UNITED STATES OF AMERICA
NUCLEAR REGULATORY COMMISSION

In the Matter of)	Docket Nos. 52-027-COL
)	52-028-COL
SOUTH CAROLINA ELECTRIC & GAS)	
COMPANY AND SOUTH CAROLINA)	
PUBLIC SERVICE AUTHORITY (ALSO)	
REFERRED TO AS SANTEE COOPER))	
)	
(Virgil C. Summer Nuclear Station Units 2)	September 27, 2011
and 3))	
)

**SOUTH CAROLINA ELECTRIC & GAS COMPANY’S ANSWERS TO THE
COMMISSION QUESTIONS FOR THE V.C. SUMMER UNITS 2 AND 3
MANDATORY HEARING**

Figure 1-3 10-Mile Emergency Planning Zone

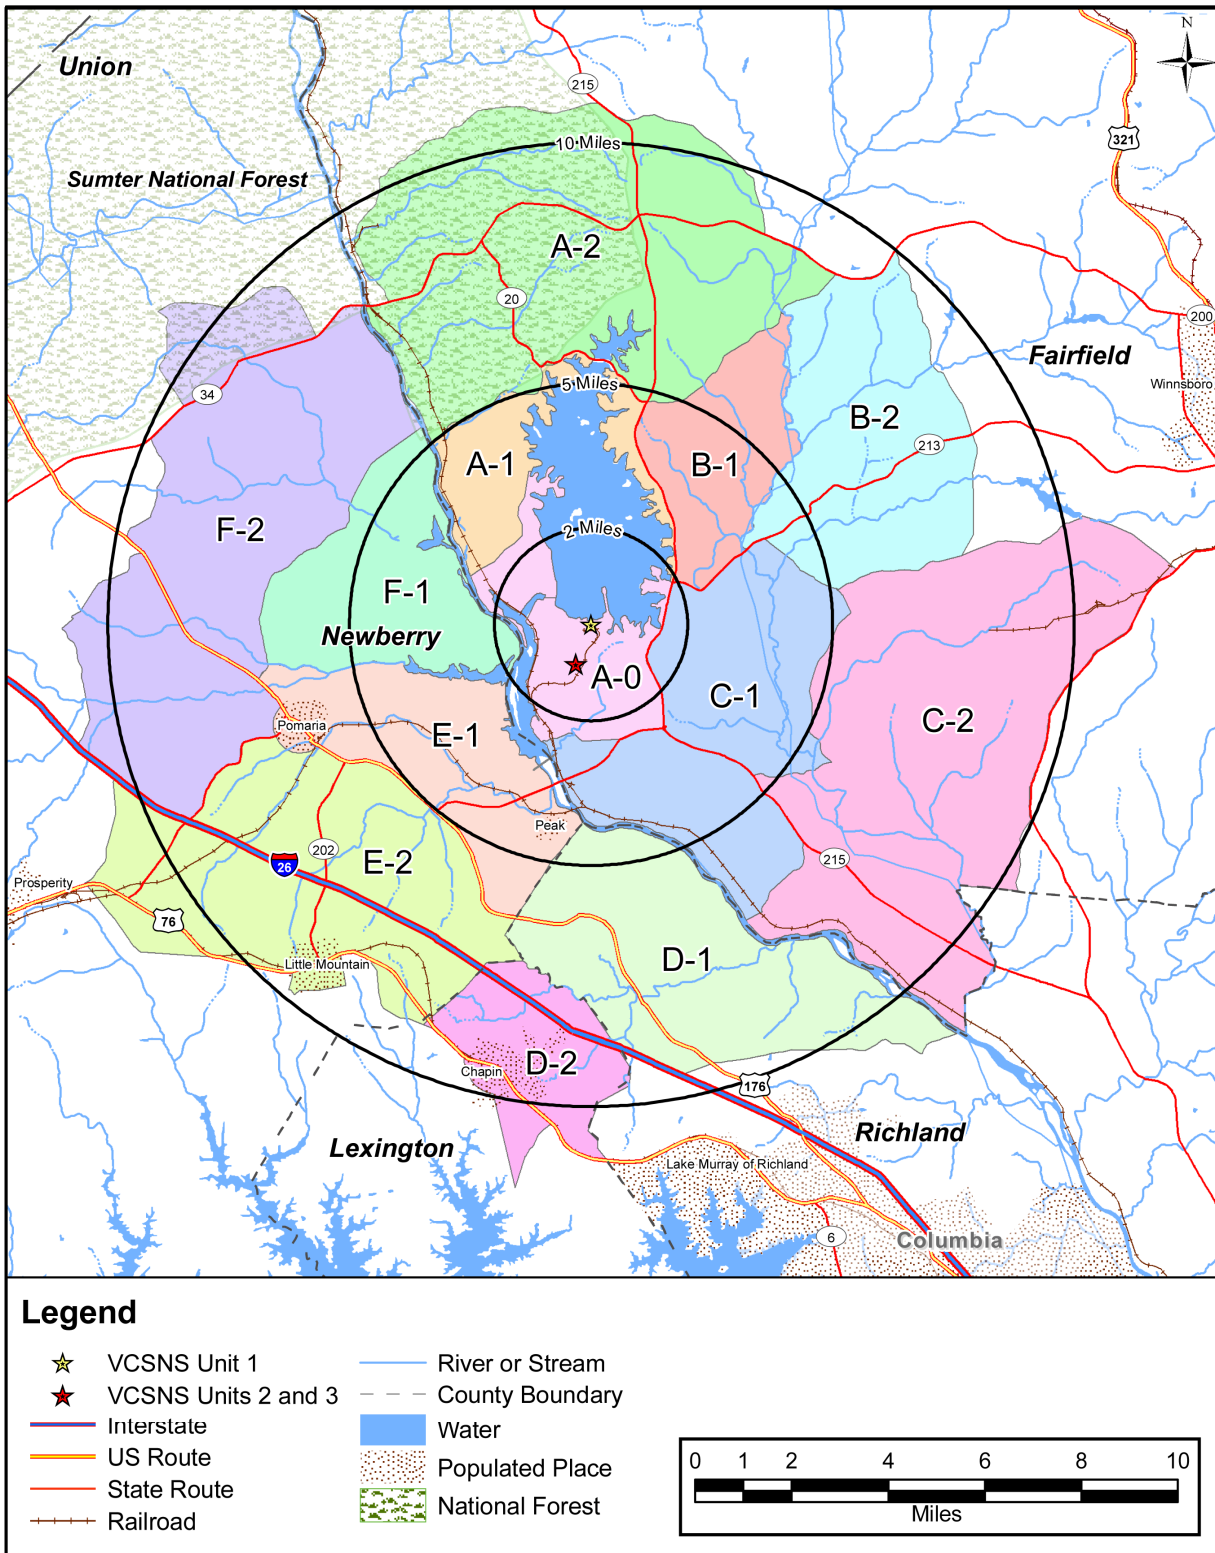
Question No.	Category	Reference	Question
13	Safety	VCS DEP 18.8-1 SECY-11-115 p. 13 FSER Attach. 13.3A	Please provide a map of the EPZ for Units 2 & 3 (or a reference to an RAI response containing a map).

The Emergency Plan for V.C. Summer Units 2 and 3 is provided in COLA Part 5 (ADAMS Accession No. ML110410260). Figure 1-3 of the Radiation Emergency Plan provides a map of the 10-mile Emergency Planning Zone for Units 2 and 3. A copy of this figure is provided as Attachment 1 to this document.
